Oregon State University
Capital Projects Contract Administration
Gilmore Autoclave Install

ADDENDUM NO. 1

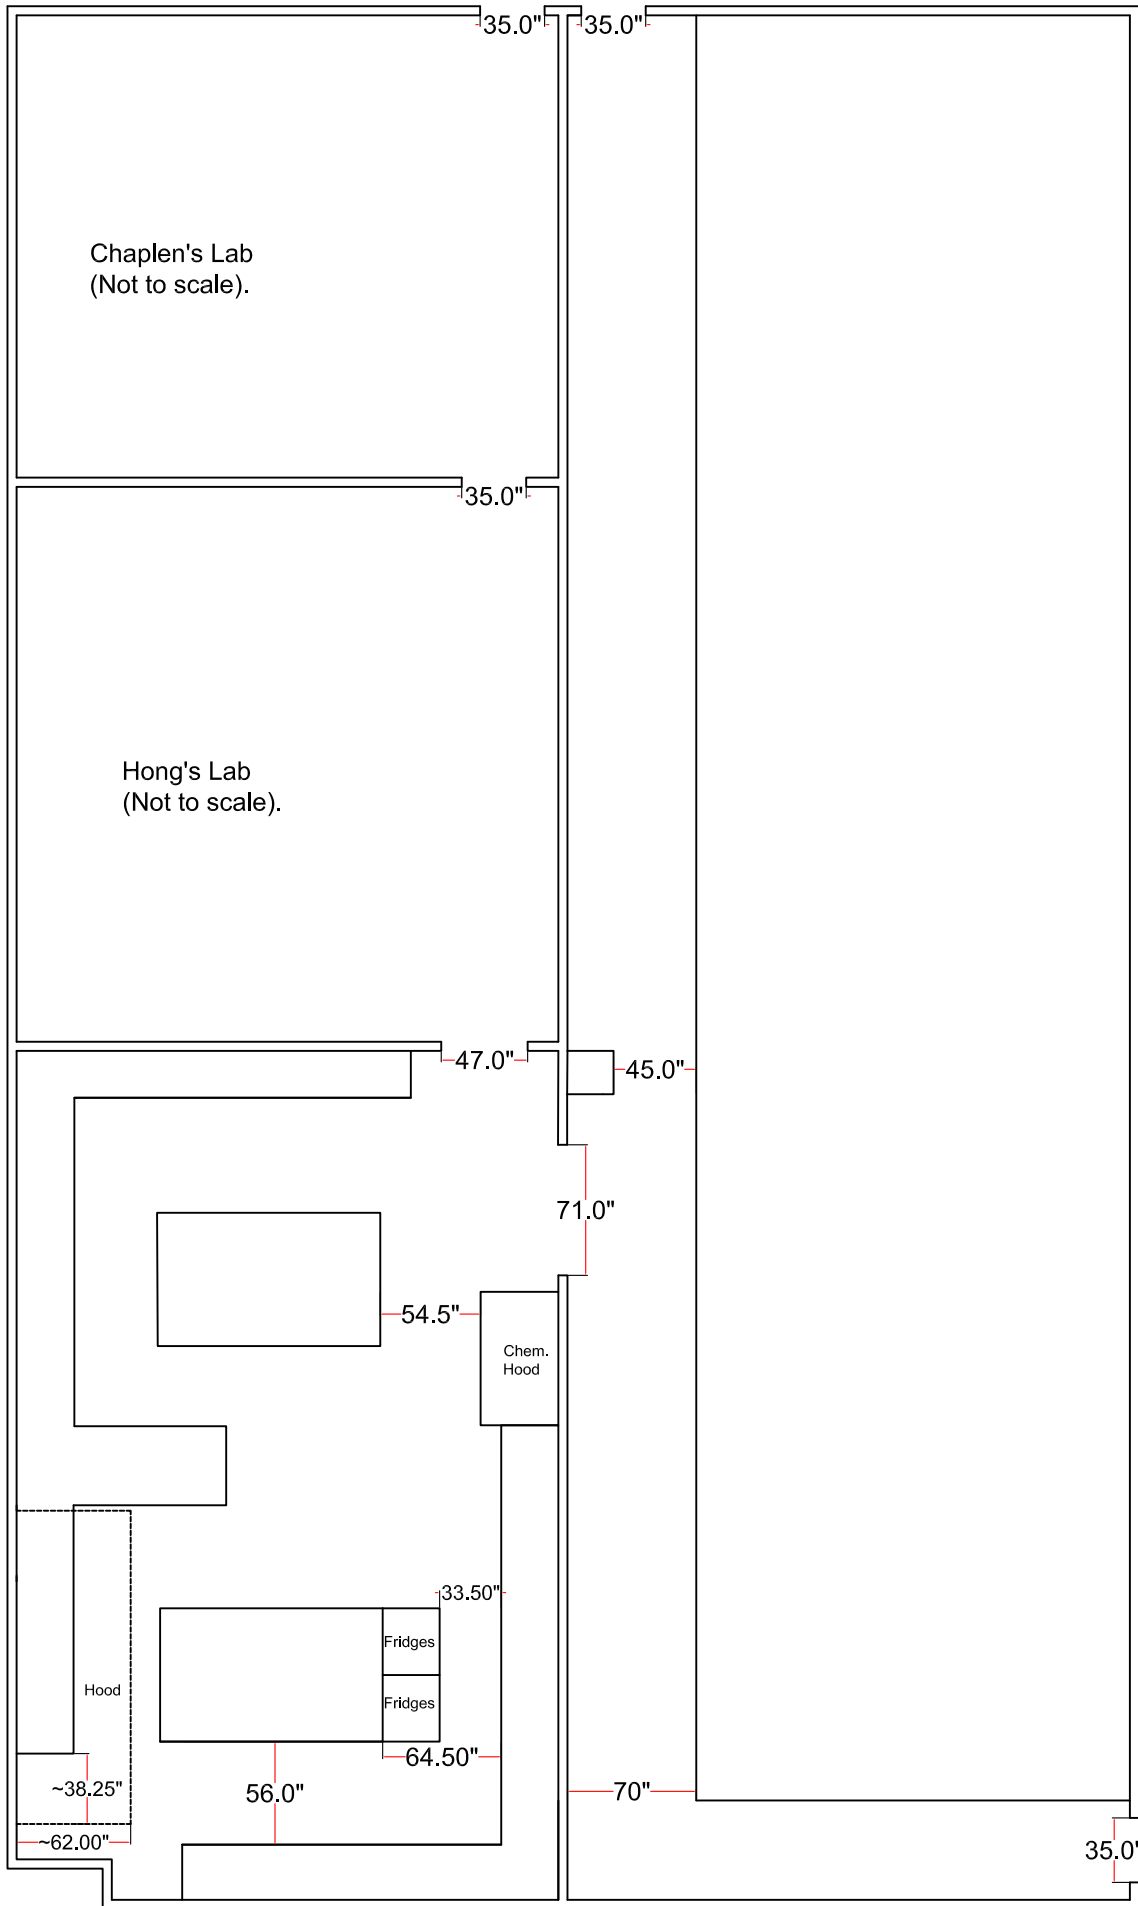
- Item 1** **Q:** Page 1 of the RFQ states that the “exact installation locations to be determined after award.” Later in the specification (item #11) it states that it will be going into 105B of Gilmore Hall, and that a freight elevator is not available. Please confirm this is a ground level installation, and that obstacles, such as stairs, are not in the pathway to the autoclave room.
A: Ground level installation constrained as indicated on the attached plan.

- Item 2** **Q:** Can you provide a floor plan room drawing or dimensioned sketch?
A: Floor plan provided.
- Item 3** **Q:** Will building compressed air (75 PSI minimum) be available at the autoclave?
A: No compressed air is available.

Hallway to exterior doors with no step

Location of current autoclave

Exterior kerb and step up
